RBKC MOE - P1
Comments in blue by RBKC Building control

| GRENELL TOWER REGENERATION PROJECT | | |
| FIRE ACCESS PLAN | | |
| 1279 (08) 100 00 | | BS |

1 MEZZANINE
1:100

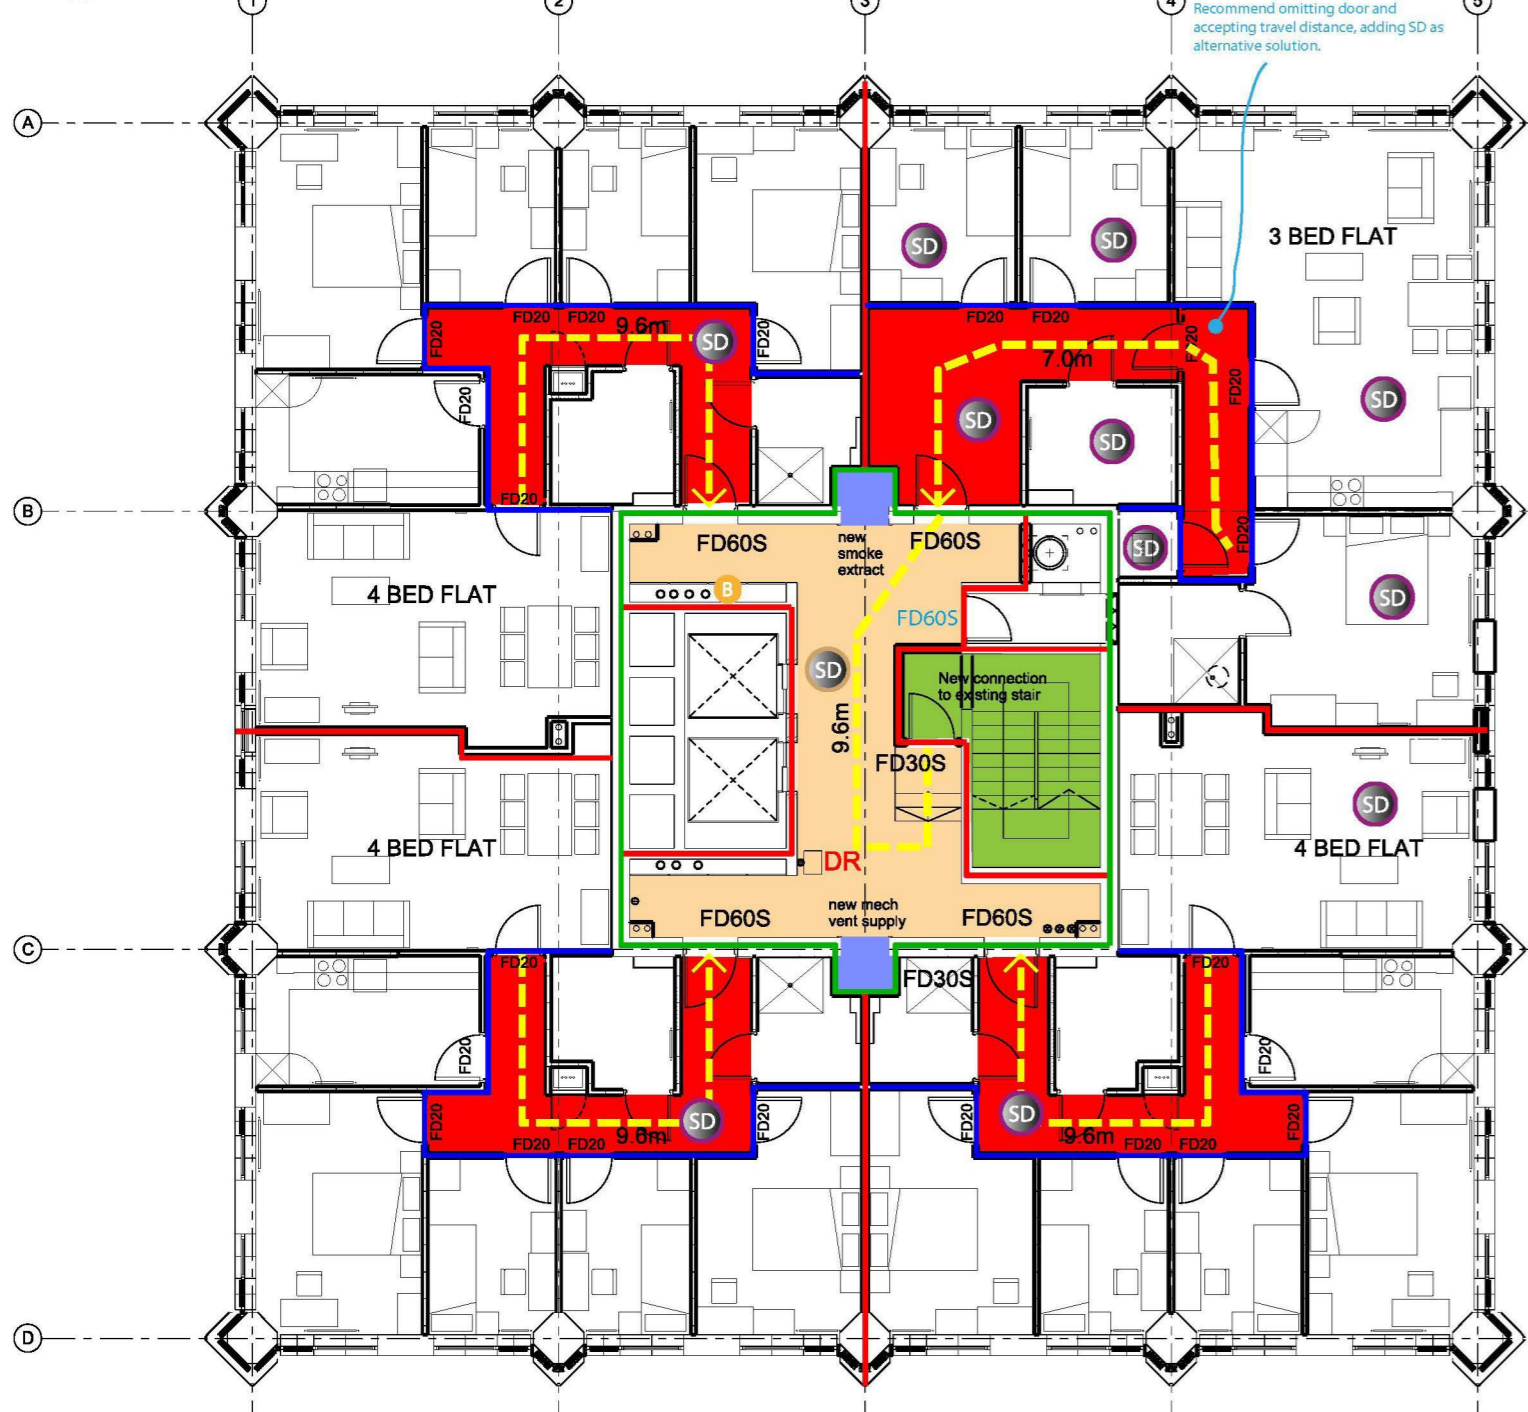
This is a room. Venting the room would not provide the same level of protection as venting a lobby thereto. In this case an unvented lobby separation to the residential escape is considered appropriate.

Route of powered vent duct, is not shown carried down to serve lobby on floor below - mezzanine. No access should be provided to stairway enclosure (green area)

Route of 0.4m² duct to 'lobby'? Duct should be enclosed with fire resisting construction to external air.

2 WALKWAY LEVEL
1:100

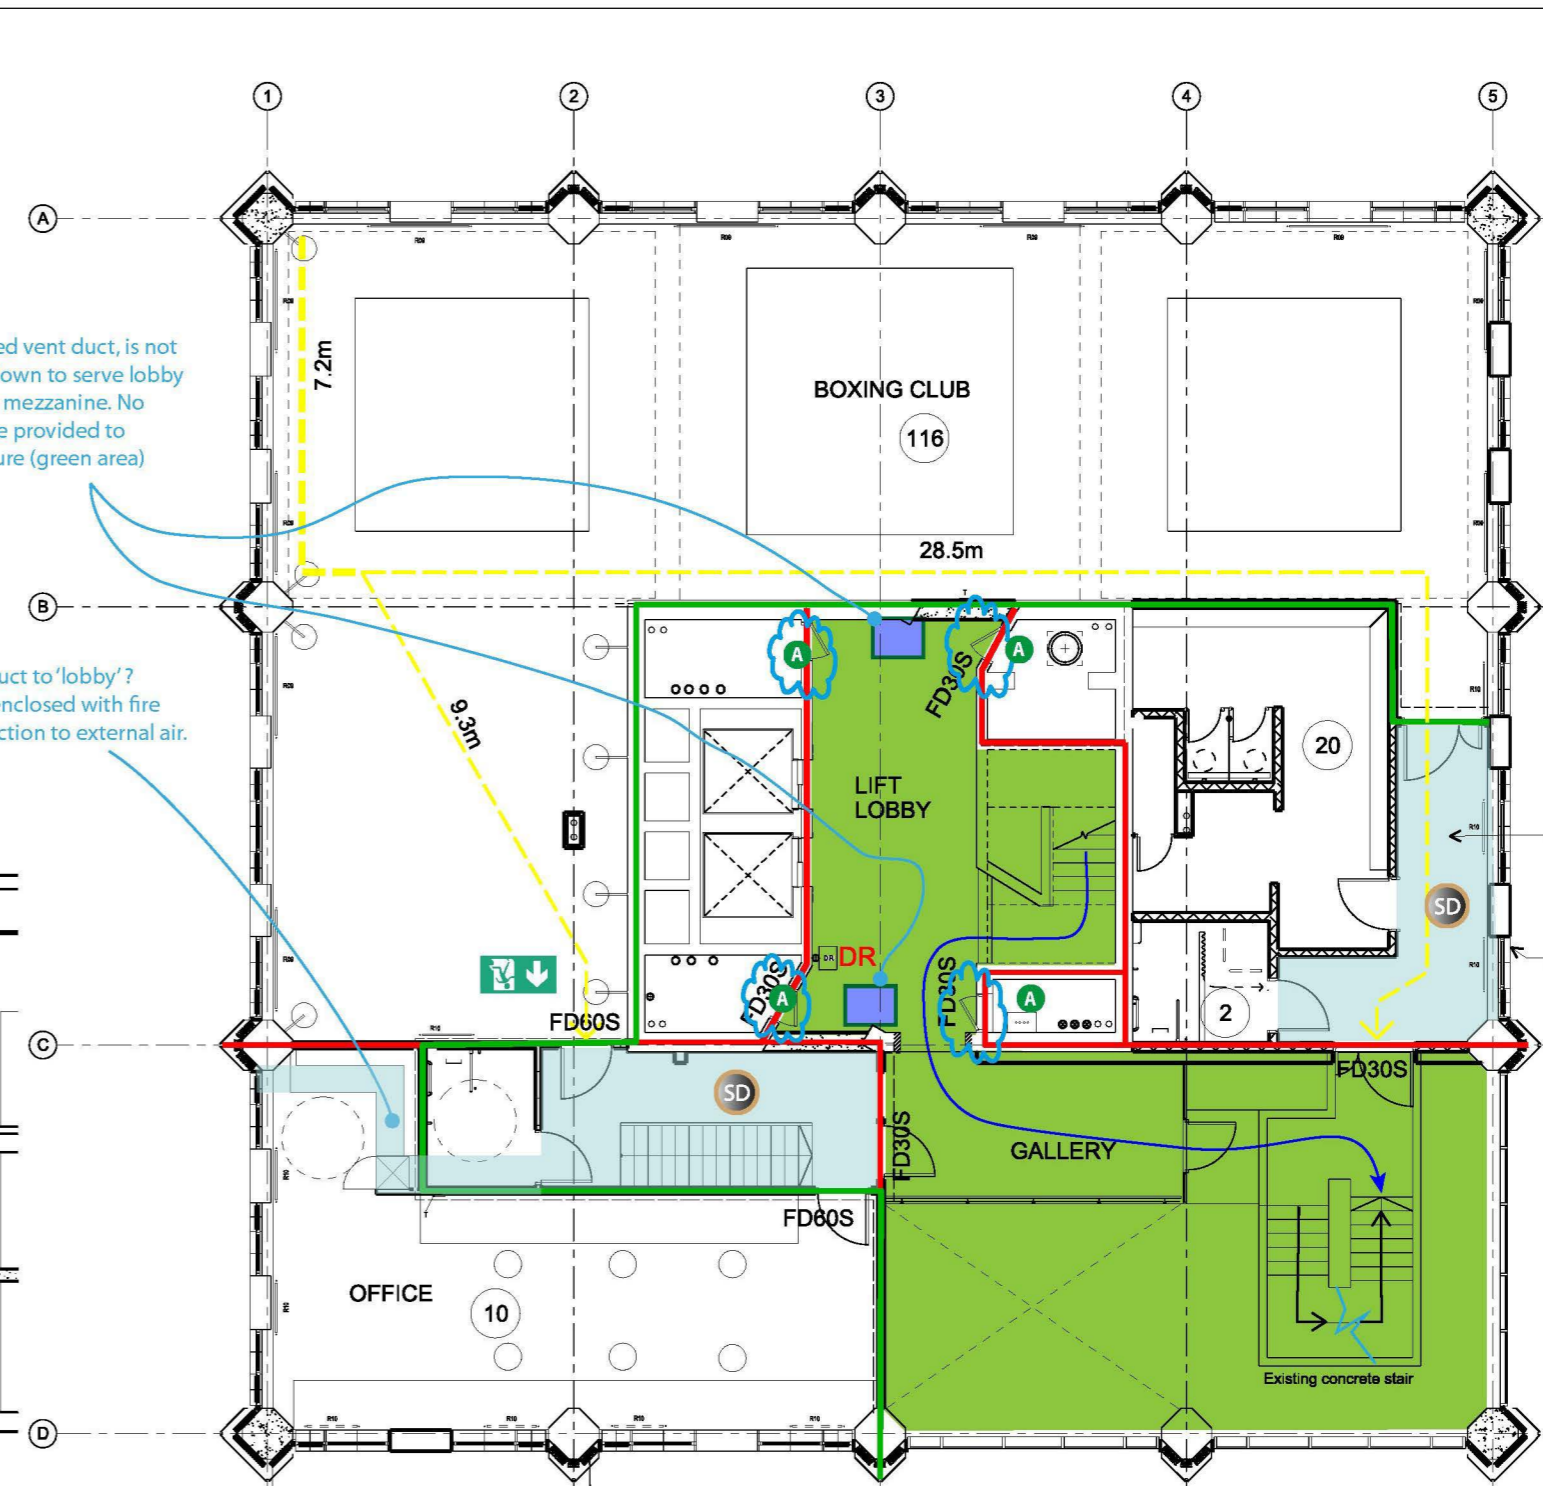
No details of existing extract / supply rates are given therefore no consideration could be given of adverse affect on existing system. If system designers wish to redesign the system without consideration of adverse affect, justification for the proposed extract rate needs to be submitted, including performance modelling.

Access should not be provided to services from the single stairway. (Hot and cold water/dry riser services are acceptable in metal pipes with suitable fire stopping). (Note in the existing building these risers were in the lobby). Can these access panels be sealed at this level?

Risers accessed from common Lobbies
Fire resistance should be achieved from the riser side of the enclosure. Access to services from the lobby should be via an FD30S with 'Fire Door Keep Locked Shut' signage.
